# GULF STATES UTILITIES COMPANY

River Bend Station - Unit 1  
Docket No. 50-458

Please find enclosed responses to the requests for information contained in your letter of April 30, 1991.

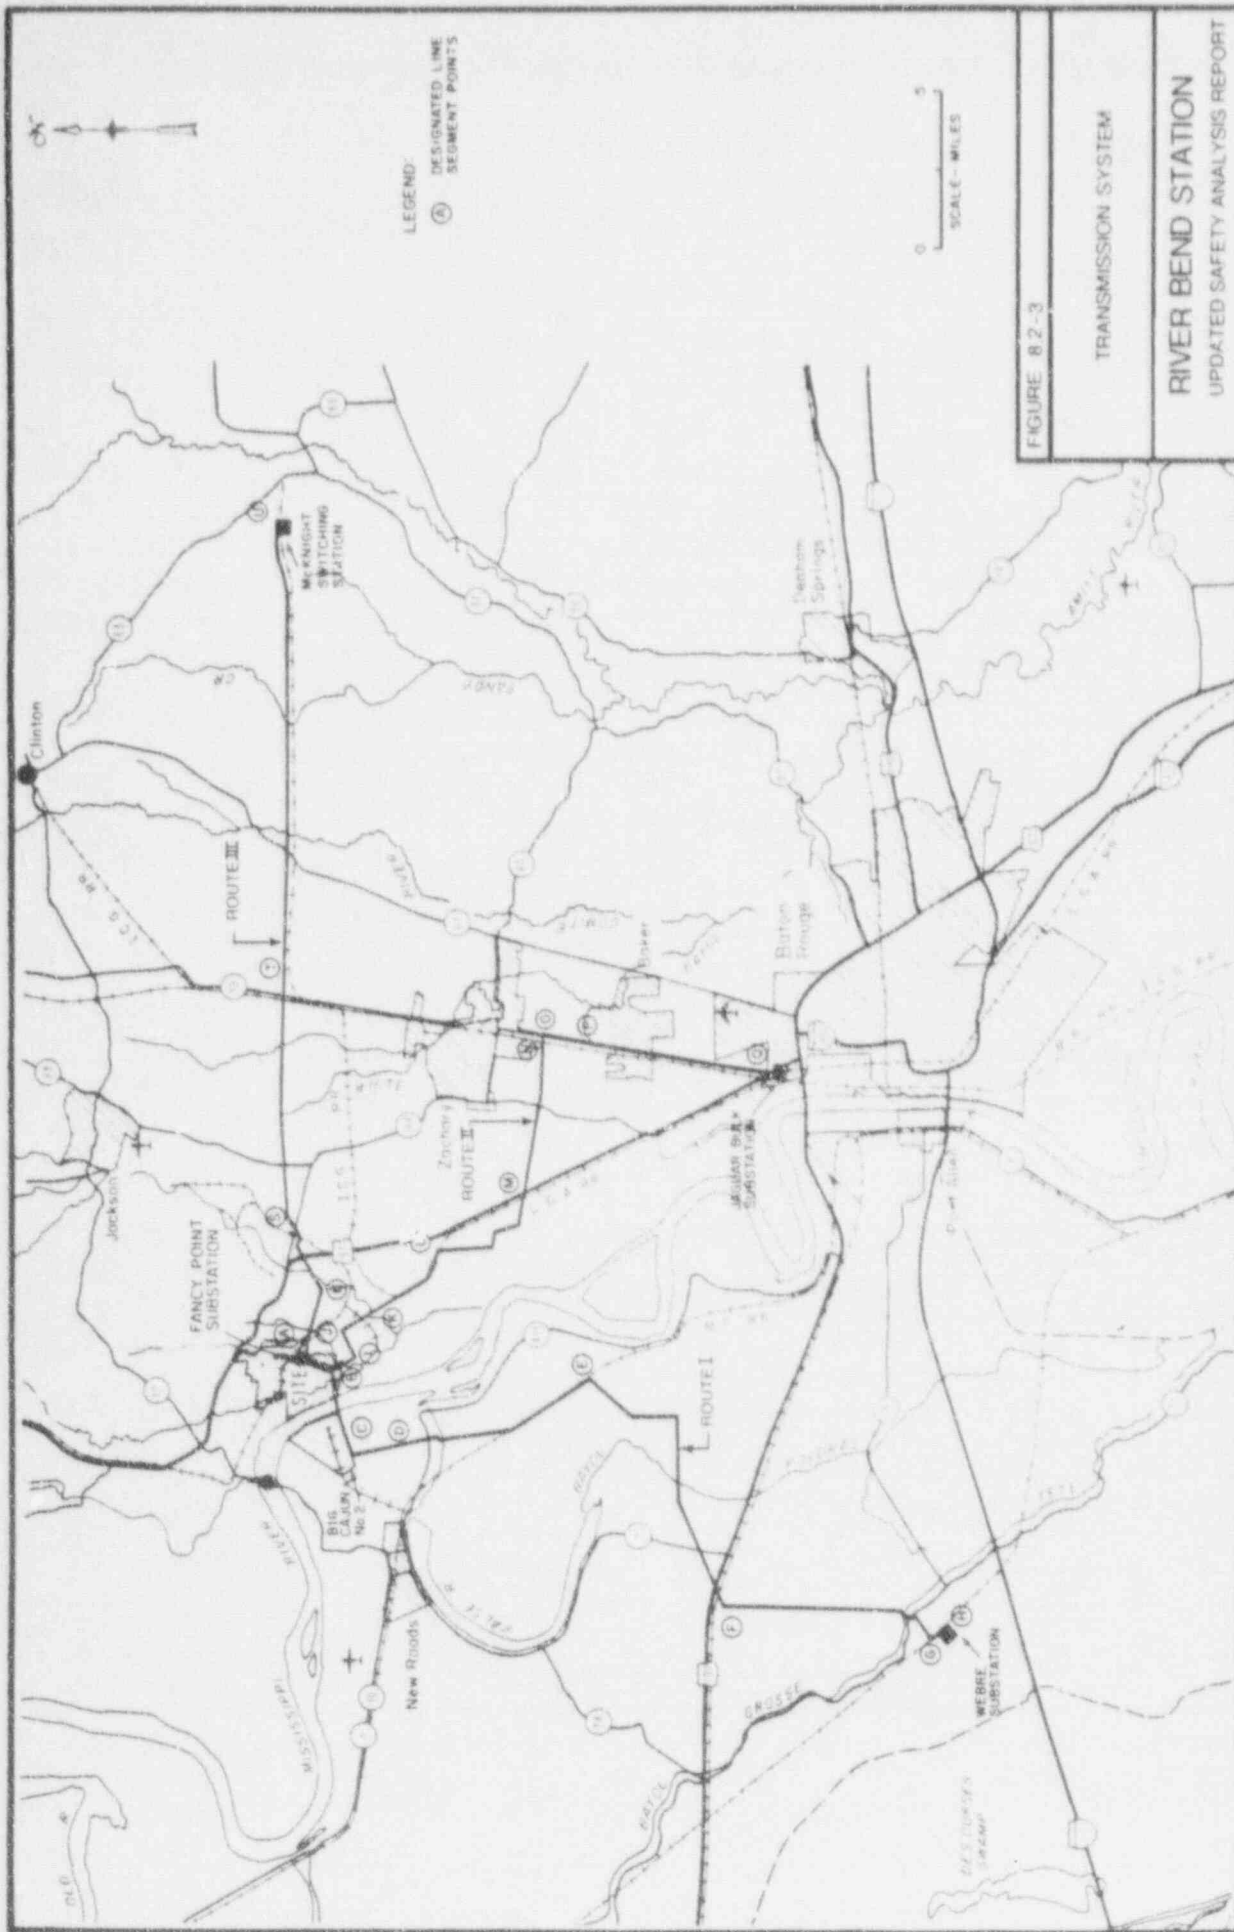
Recently, GSU applied for an emergency permit to shore up a transmission tower on a 500 kV line, which was experiencing erosion. (We understand that, over the past 26 years, the river has shifted 200 feet to the west and is now affecting the base of the tower.) Section 8.2.1.3 of the Updated Safety Analysis Report (USAR) states that transmission lines of GSU are inspected aurally on a monthly basis. The concern is that GSU has not been performing the monthly aerial inspections. Your response should include a copy of the results of the monthly aerial inspection activity for the past 24 months.

The transmission line tower alluded to (structure 276) is located where 500 kV line designated 742 is in close proximity to the Amite River north of GSU's McKnight substation. For NRC safety and environmental licensing purposes, the new transmission lines constructed with River Bend Station terminate where they connected with the existing transmission system grid. As described in USAR Section 8.2.1.1.2 and shown in Figure 8.2-3 (attached), 500 kV line 752 (Route III) terminates at McKnight substation. This tower therefore is located on a non-RBS associated transmission line.

At the time of RBS licensing, GSU flew aerial inspections of the transmission system monthly. The monthly flying schedule did not allow adequate time for the identification and subsequent inspection and correction of findings by field crews before the next aerial patrol was flown. Since that time GSU has reduced the flying schedule to approximately three times per year. If serious problems are found, prompt corrective actions are undertaken and increased patrols may be utilized.

It is true that the Amite River has for years been migrating to the west at this location. GSU has been aware of this development and has been monitoring by field inspection the progress of the river and its effects on this transmission tower since its construction in 1967. When the river began undercutting the forty foot deep steel sheet pile cell placed around the base of the tower in 1973 to protect the tower from the erosional effects of the river, an emergency permit from the U.S. Army Corps of Engineers was sought and received in 1990 to repair and stabilize a small sinkhole formed in the pile cell. Regardless of the frequency of aerial patrols, the subsurface undercutting of the base of this tower could not have been observed by aerial inspection early enough to take corrective action. GSU believes that the corrective and preventive measures taken will assure the stability of the tower. Inspection after major floods and sounding the riverbed depth annually will continue for as long as the pile cell remains in the main river channel.
